TO: Jessica McCallum, Kimley Horn
FROM: BrieAnna Simon, Associate Planner
DATE: November 8, 2021
SUBJECT: Douglas 234 F6 AMD 1 L3 – McDonalds (SP21-067)
Review Comments v2

DOUGLAS 234 FILING NO. 6, LOT 3

A2.1
ELEVATIONS

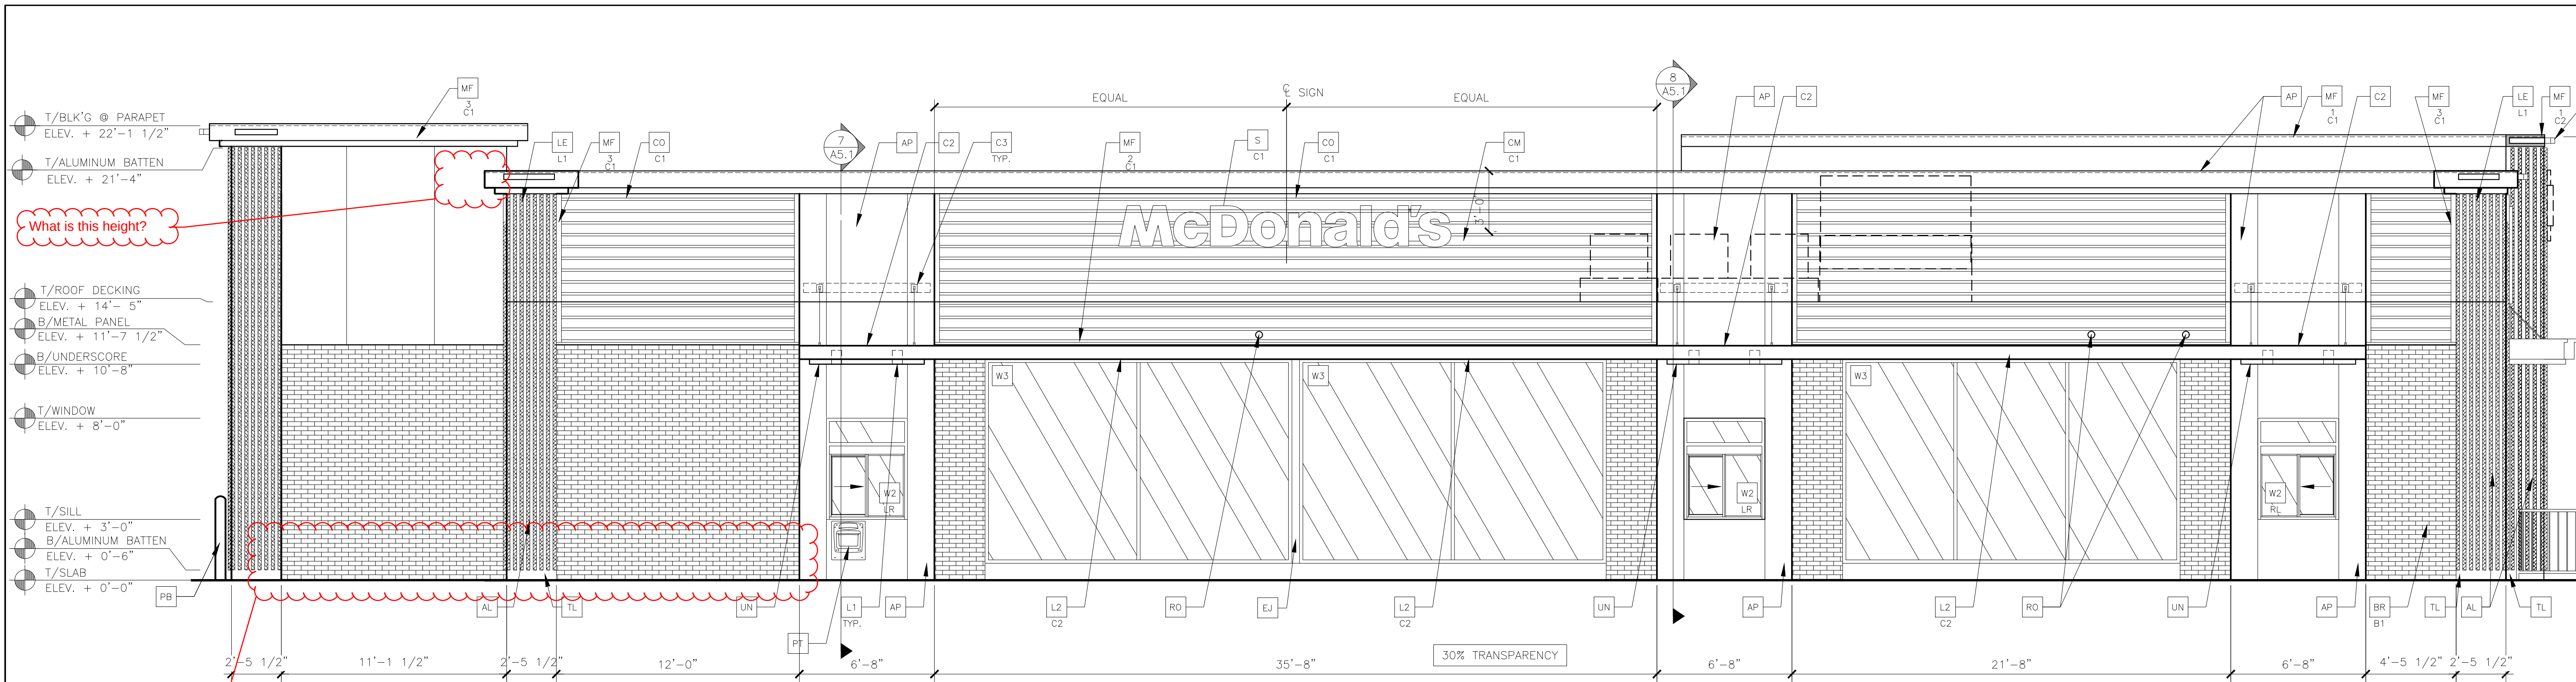
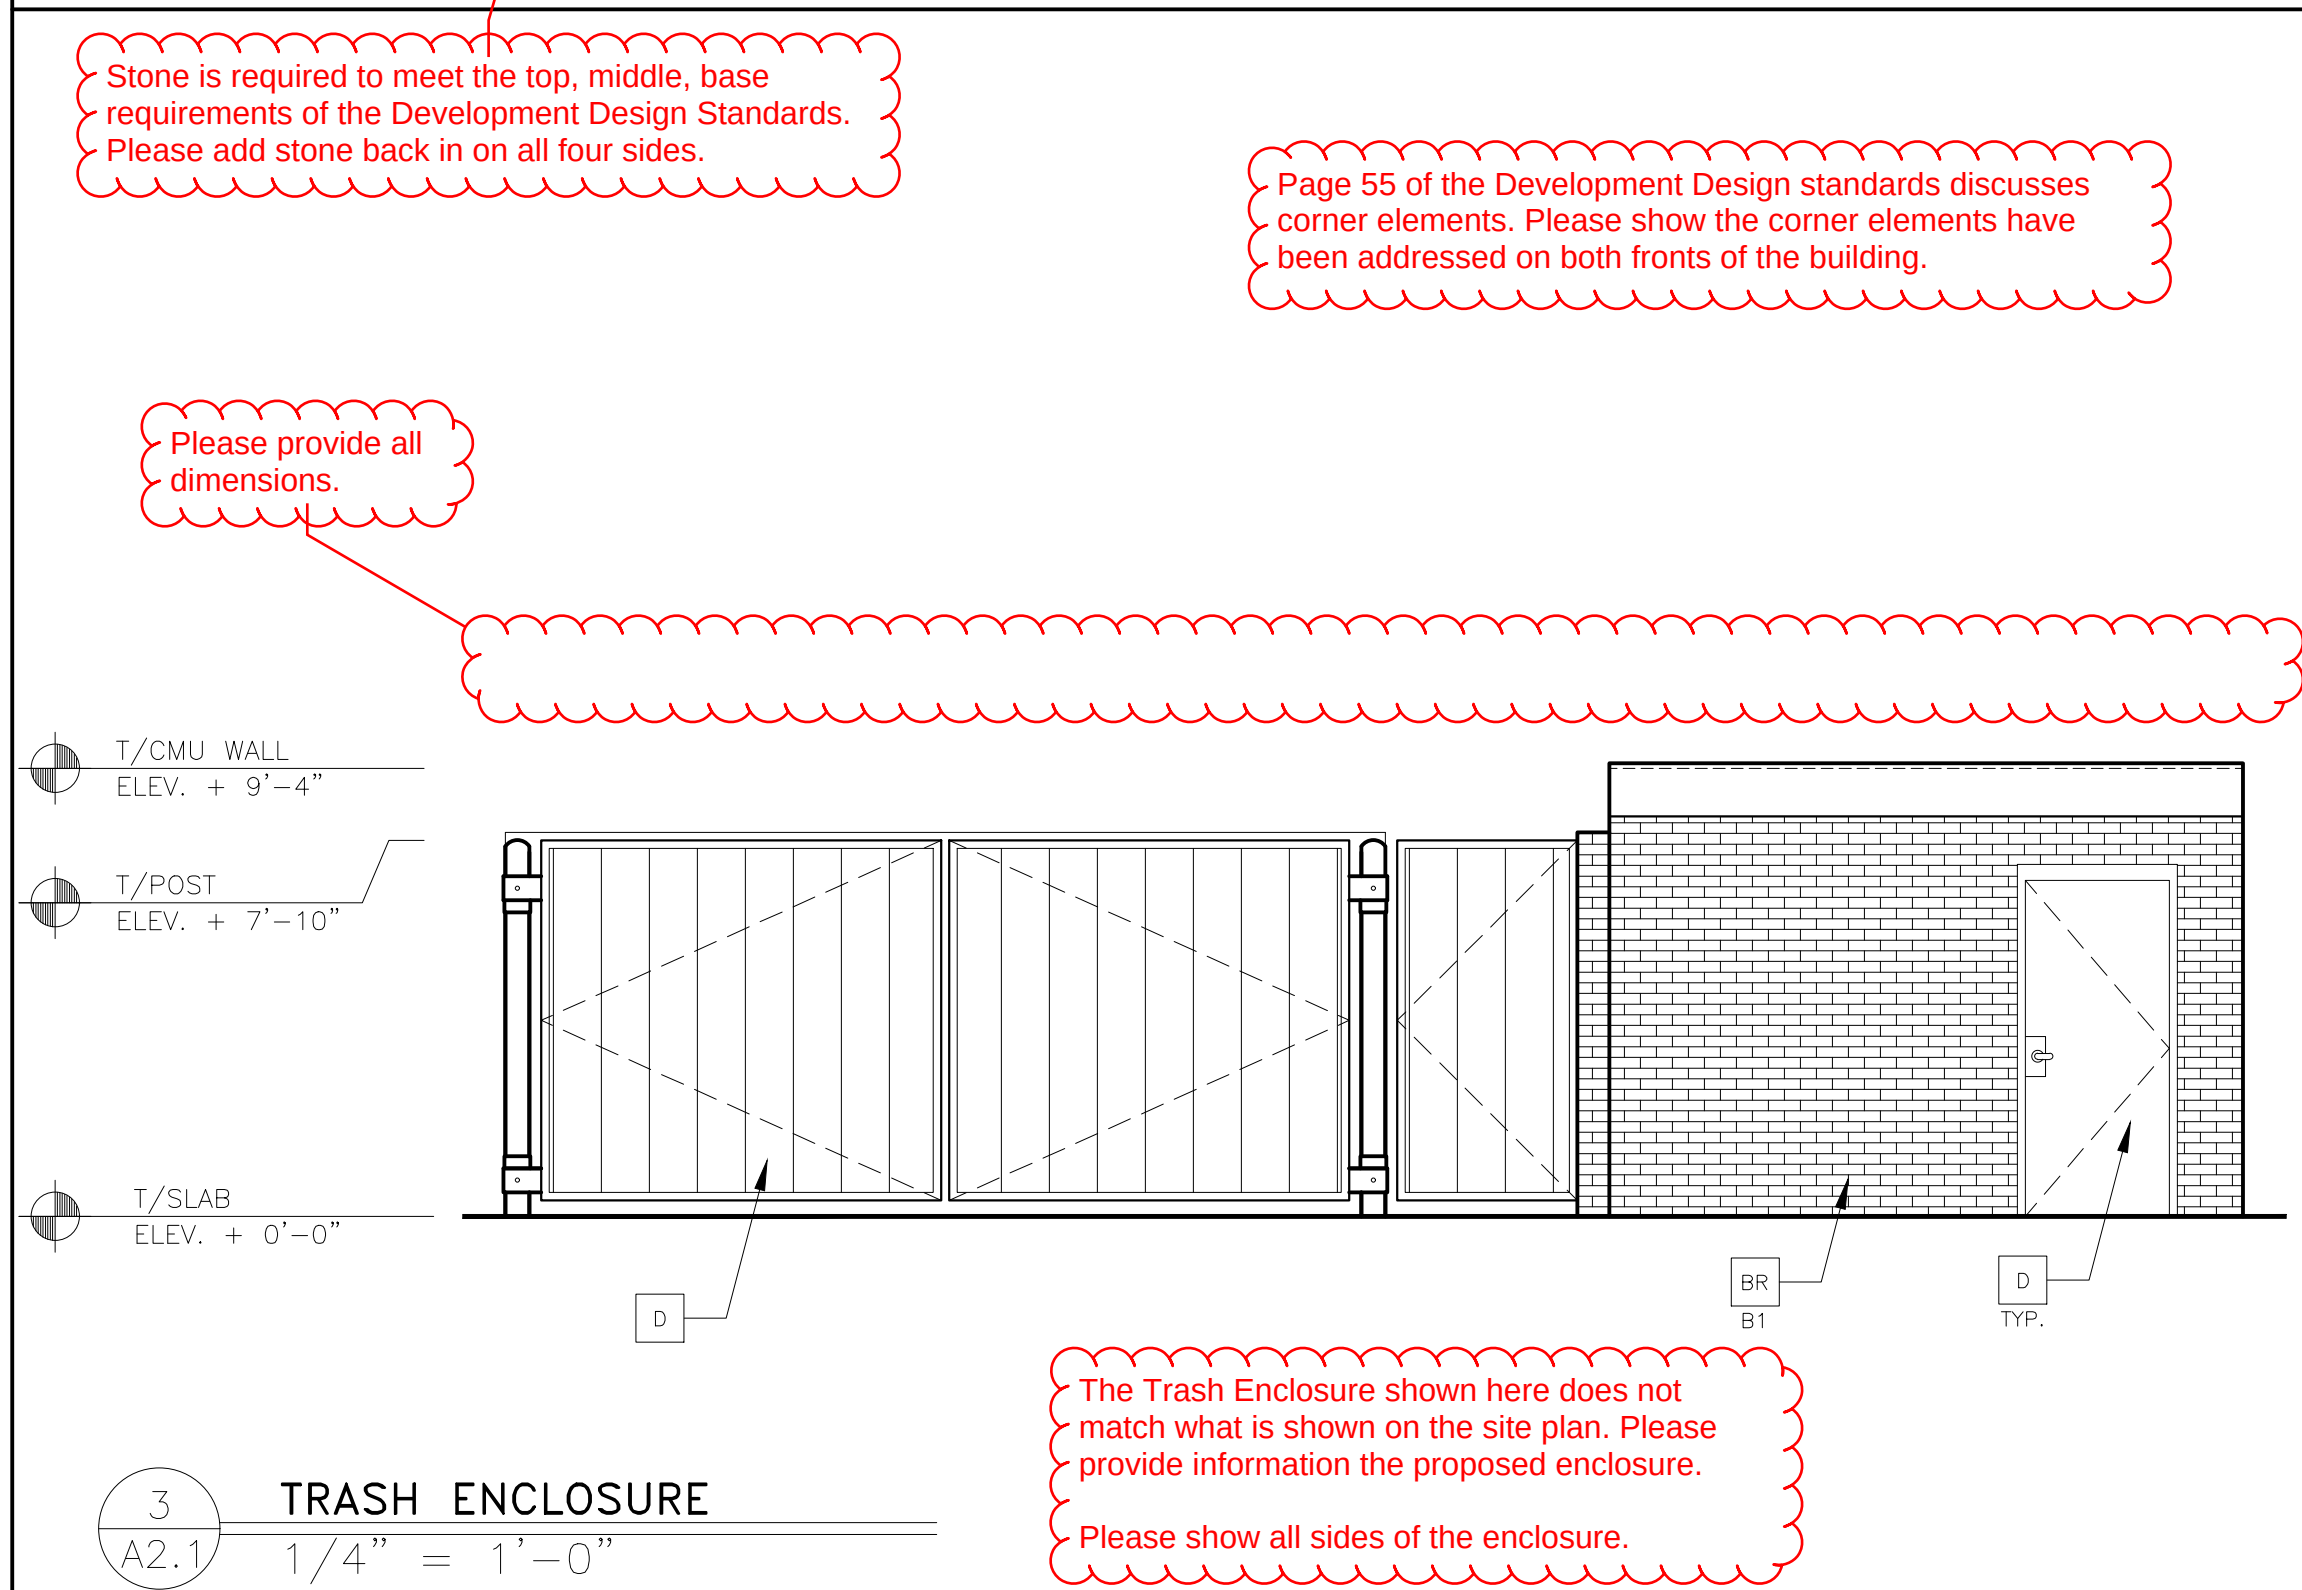
THE TRASH ENCLOSURE SHOWN HERE DOES NOT MATCH WHAT IS SHOWN ON THE SITE PLAN. PLEASE PROVIDE INFORMATION THE PROPOSED ENCLOSURE.

PLEASE SHOW ALL SIDES OF THE ENCLOSURE.

PLEASE PROVIDE ADDITIONAL INFORMATION ON THE PROPOSED WINDOWS AND DIFFERENCE BETWEEN THE WINDOW TYPES. ARE THESE ALL TRANSPARENT, GLAZED, BACK LIT, ETC.?

Please add all the dimensions and notes for the elevations on both the colored and black/white.

Please see comment on the site plan. This enclosure does not match what is shown on the site plan.
